UNITED STATES PATENT AND TRADEMARK OFFICE

APPLICATION NO.	FILING DATE	FIRST NAMED INVENTOR	ATTORNEY DOCKET NO.	CONFIRMATION NO.
10/662,472	09/16/2003	Motokazu Kobayashi	03500.017564	9615

Office Action Summary	Application No. 10/662,472	Applicant(s) KOBAYASHI ET AL.	
	Examiner Eugene Lee	Art Unit 2815

FIG. 3

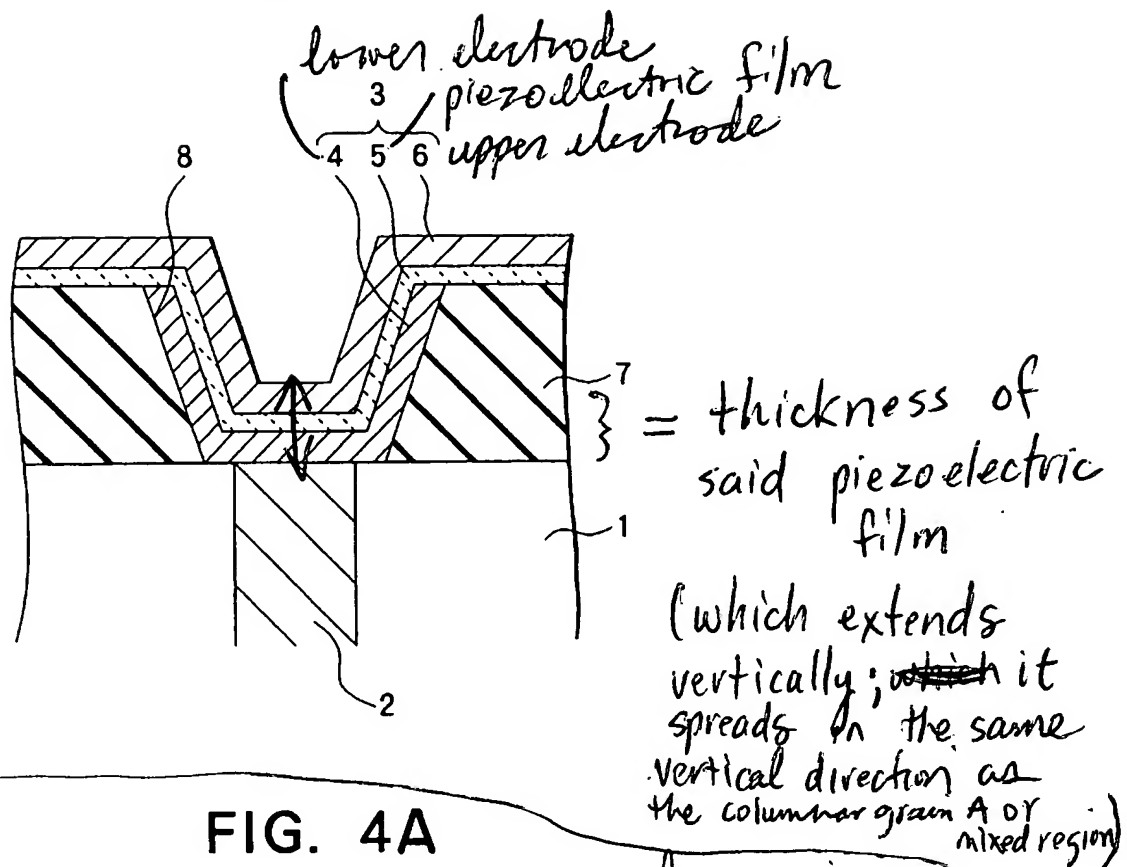
3. Claims 1 thru 4, and 11 are rejected under 35 U.S.C. 102(b) as being anticipated by Izuha et al. 6,060,735. Izuha discloses (see, for example, FIG. 3) a thin film dielectric device (piezoelectric element) 3 comprising a dielectric thin film (piezoelectric film) 5, lower electrode 4, and upper electrode 6. In column 4, lines 51-54, Izuha discloses the dielectric thin film comprising (Pb, La)(Zr,Ti) O₃ which is a piezoelectric film and a perovskite oxide. In column 7, lines 8-13, Izuha discloses the lower electrode comprising a conductive perovskite oxide. In column 5, lines 3-22, Izuha discloses the bottom electrode film and said dielectric film are composed of continuous columnar grains (mixed region) wherein the bottom electrode, dielectric, and top electrode share the columnar grains. The columnar grains are composed of

6. Applicant's arguments filed 6/26/06 have been fully considered but they are not persuasive. Please see figures below.

FIG. 4A

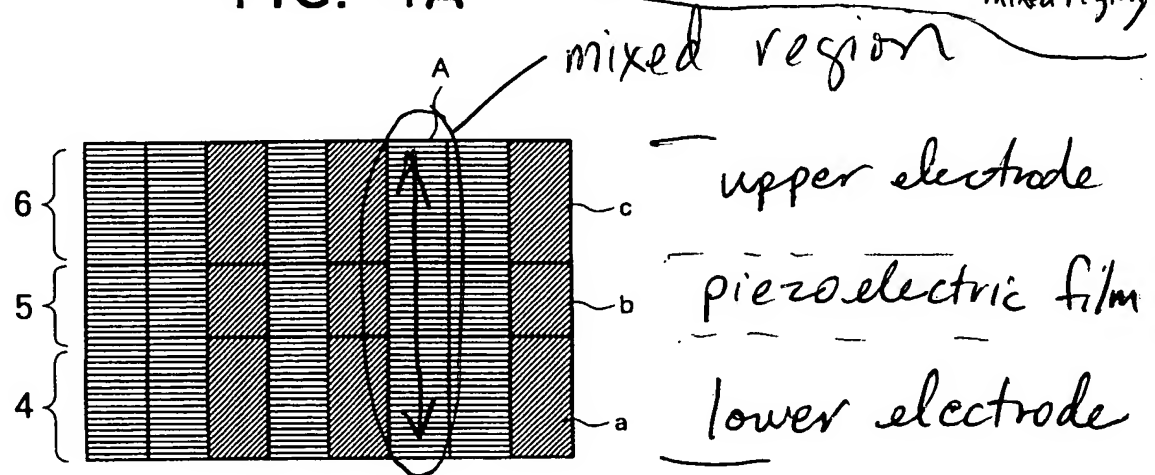
crystal grains a, b, c which grow from each other. In FIG. 4A, Izuha discloses the bottom electrode, dielectric thin film, and lower electrode sharing the columnar grains A (a region where crystals of said lower electrode and/or said upper electrode and crystals of said piezoelectric film are mixed exists between said lower electrode and/or said upper electrode and said piezoelectric film). These columnar grains A spread in a direction of the thickness of the dielectric thin film (piezoelectric film).

Regarding claim 2, see, for example, FIG. 4A, wherein Izuha discloses the columnar grain (mixed region) A which is formed from a perovskite oxide.

no interface b/t lower electrode/upper electrode/piezoelectric film b/c a single columnar grain A extends through the whole region

this region is also a mixed region
